4.2 S75W ADJUSTMENTS SCHEME ADJUSTMENT MASSING

4.3 S75W ADJUSTMENTS PROPOSED CONCEPT PLAN SCHEME

4.6 S75W ADJUSTMENTS SCHEME COMPARISON WATERLOO RD

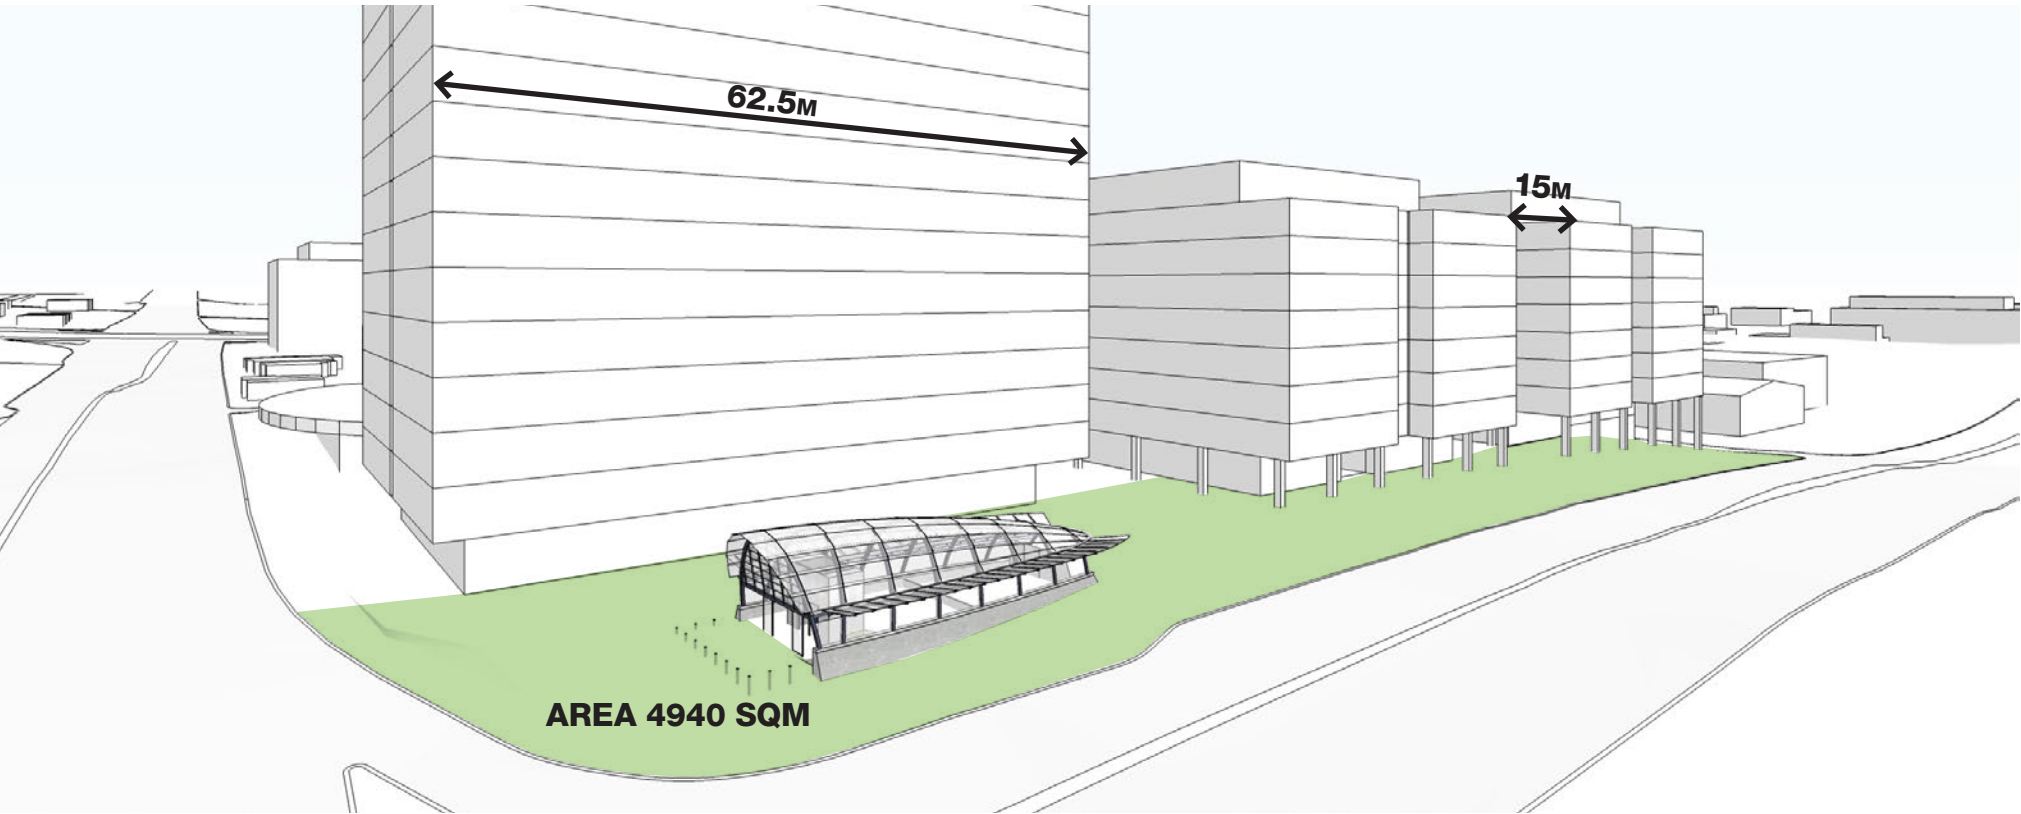
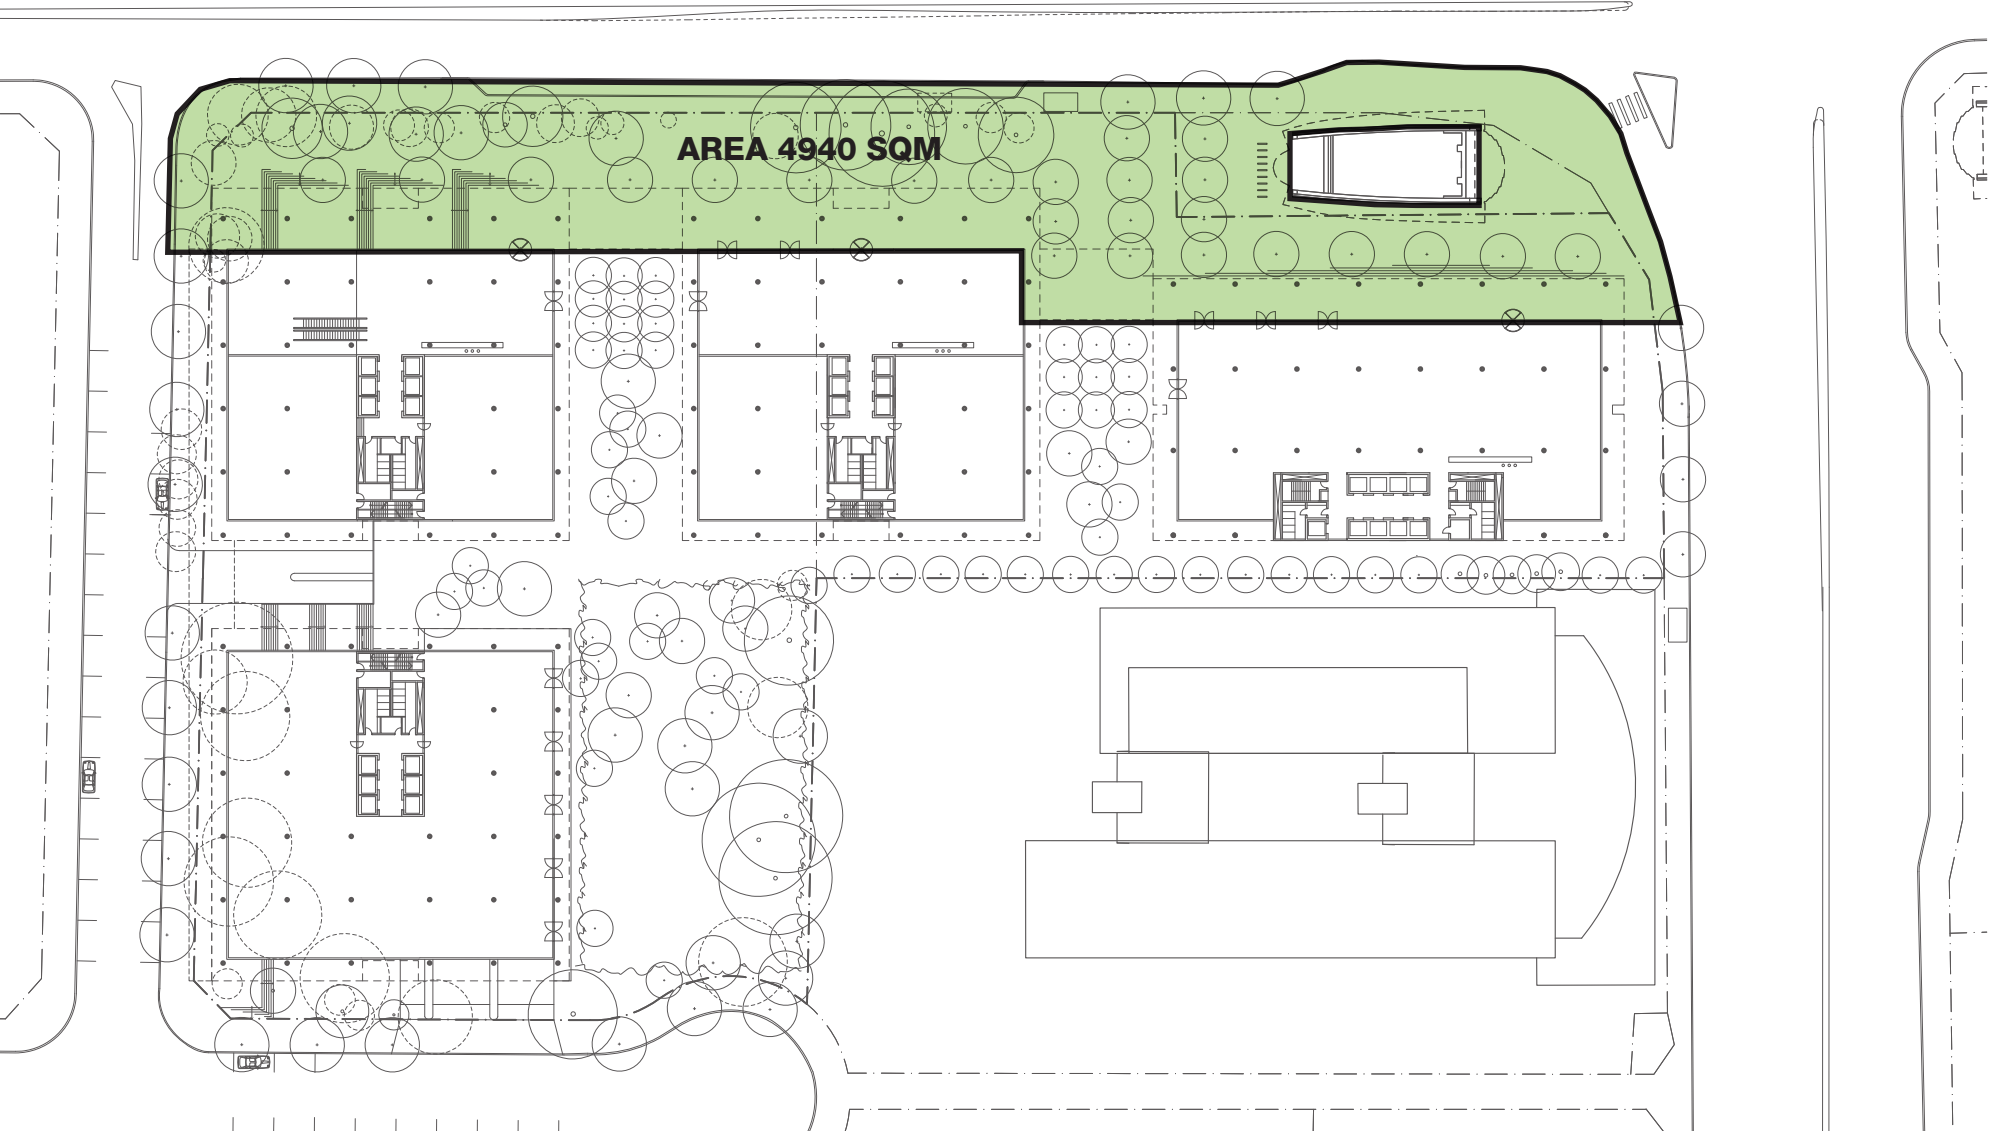
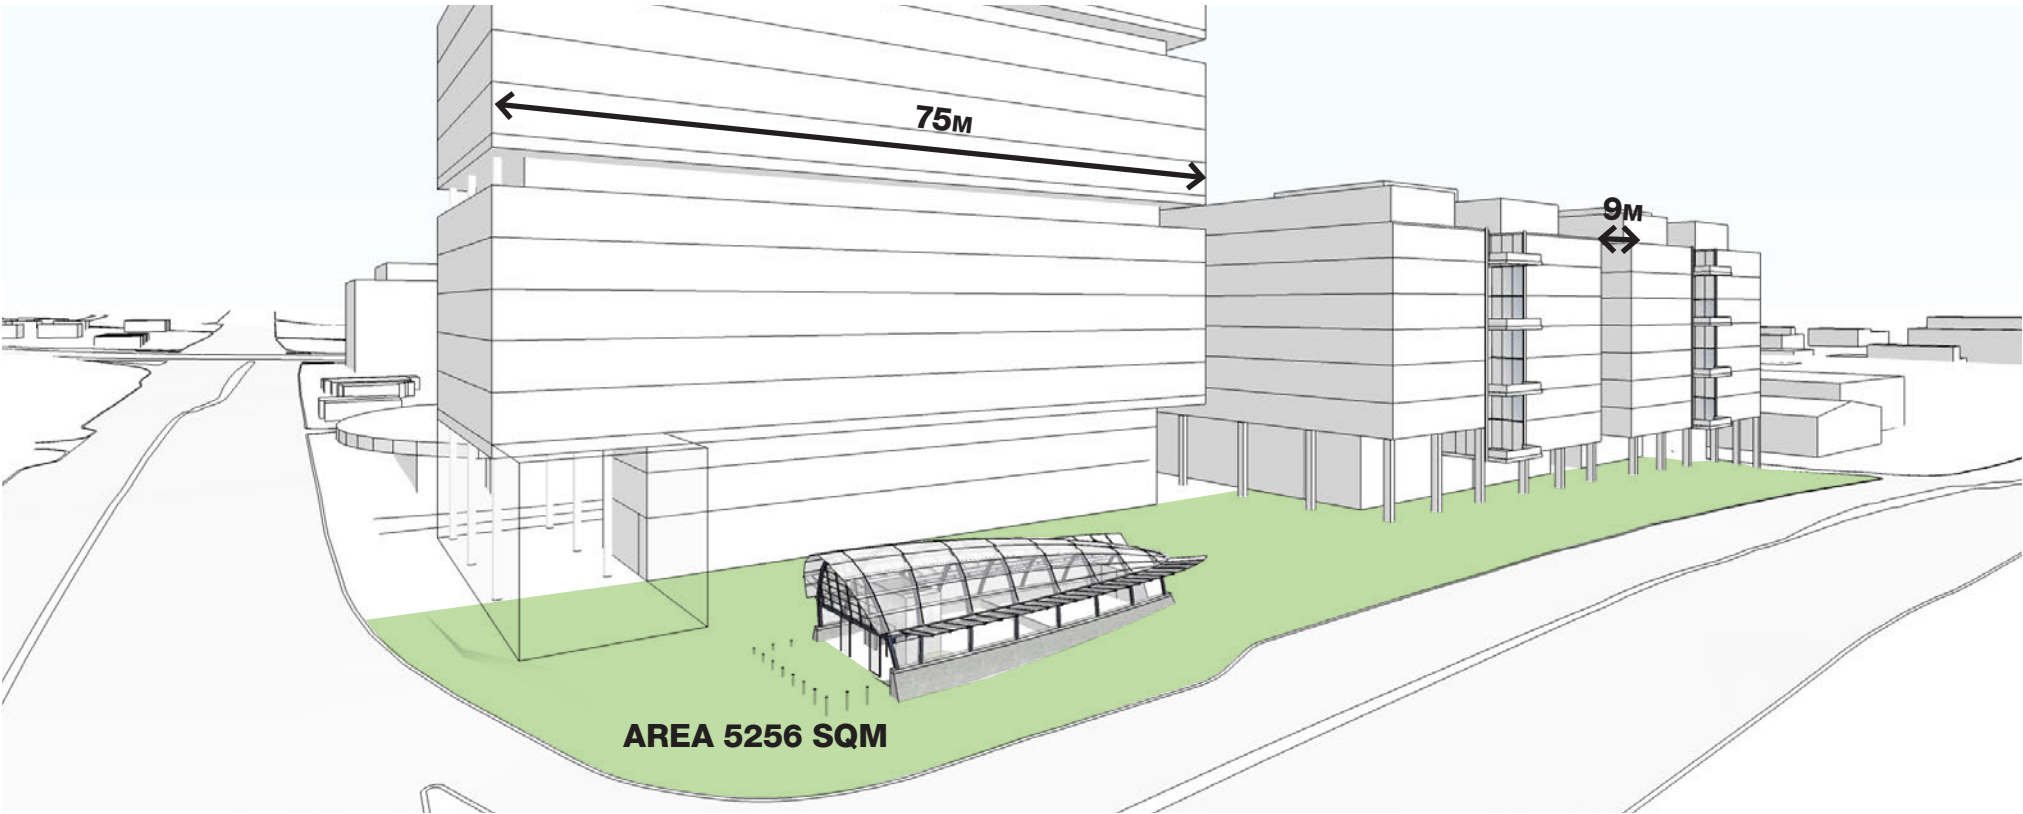
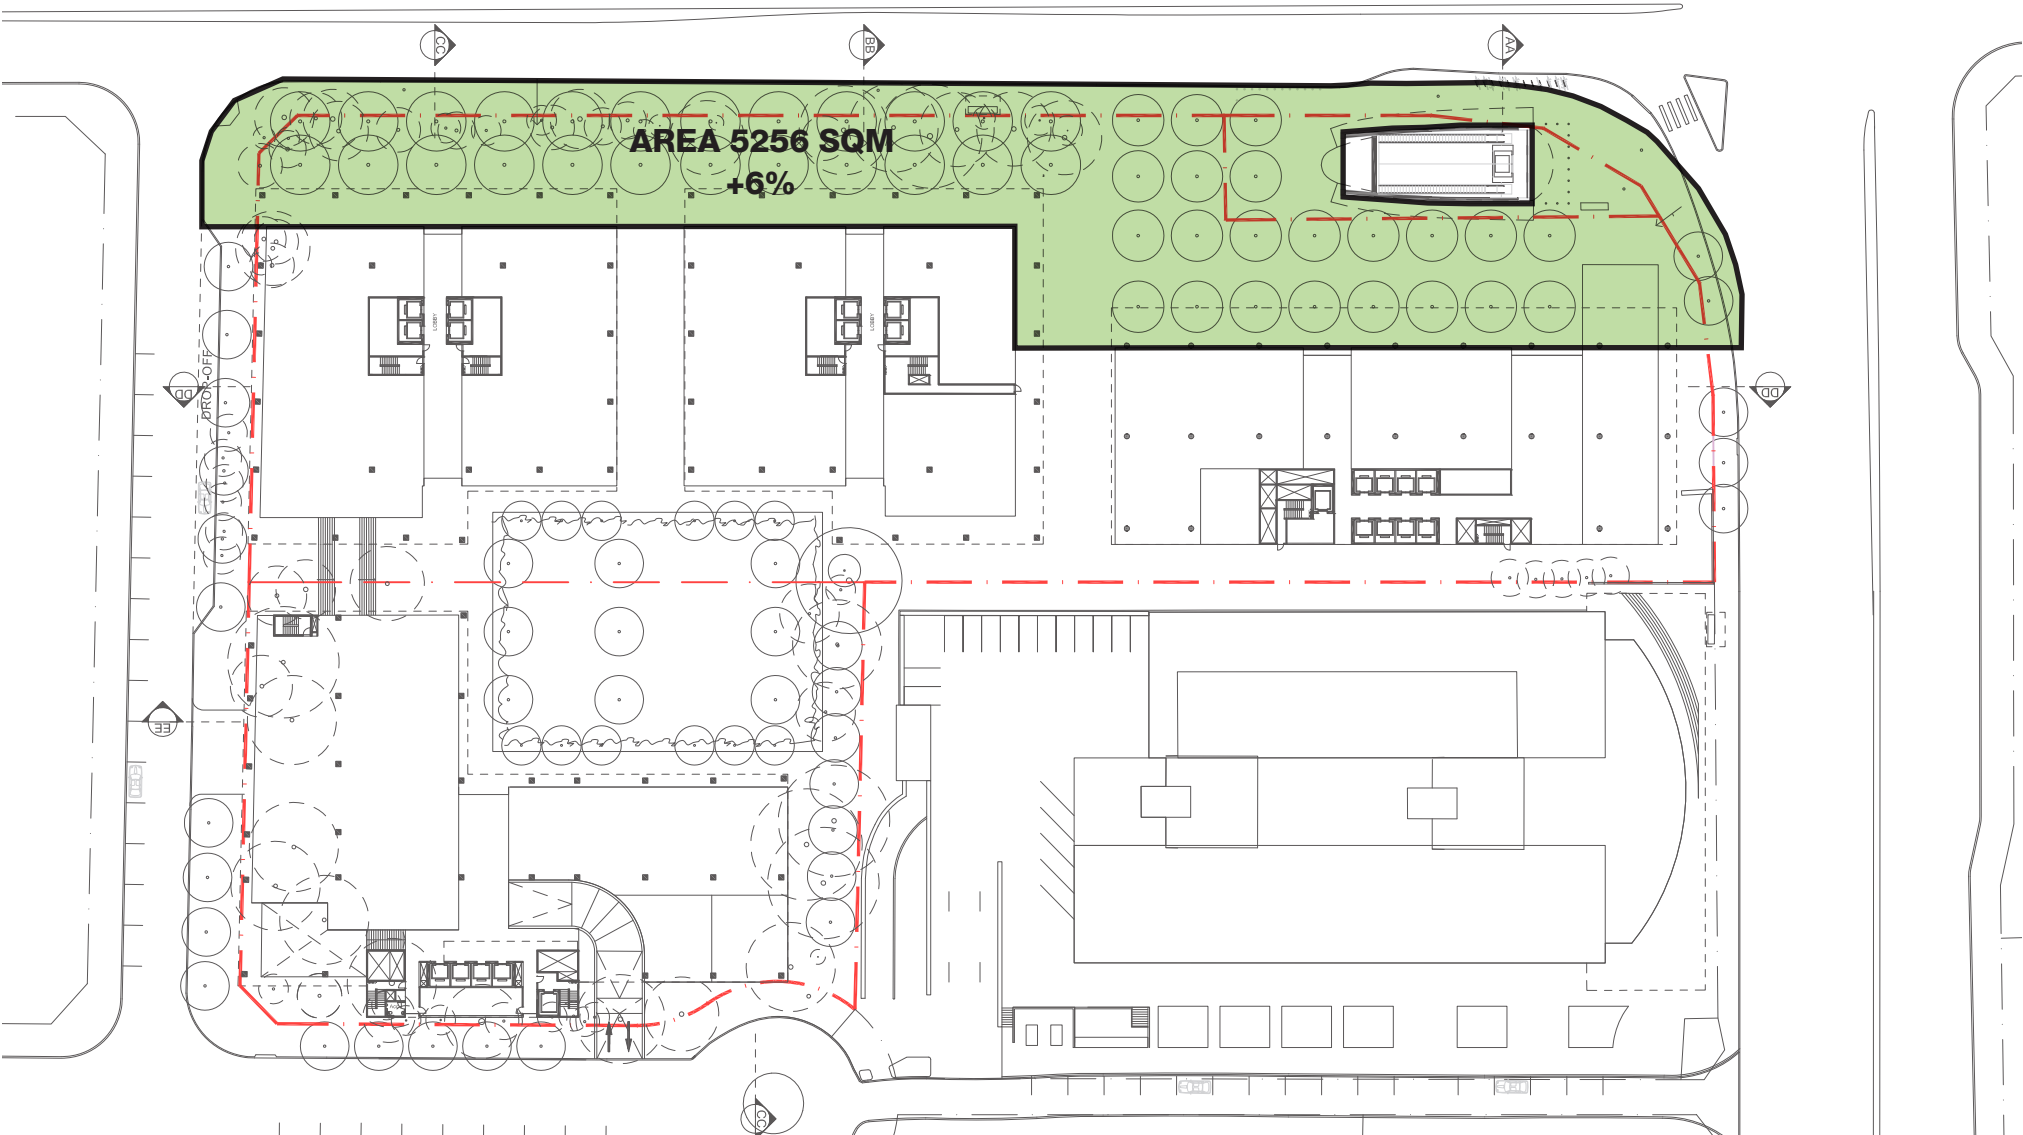
The following diagrams describe the amendments and improvements to the Waterloo Rd boulevard in the Section 75W submission.
The boulevard has increased by 6% to be 5,256sqm (an increase of 316sqm)
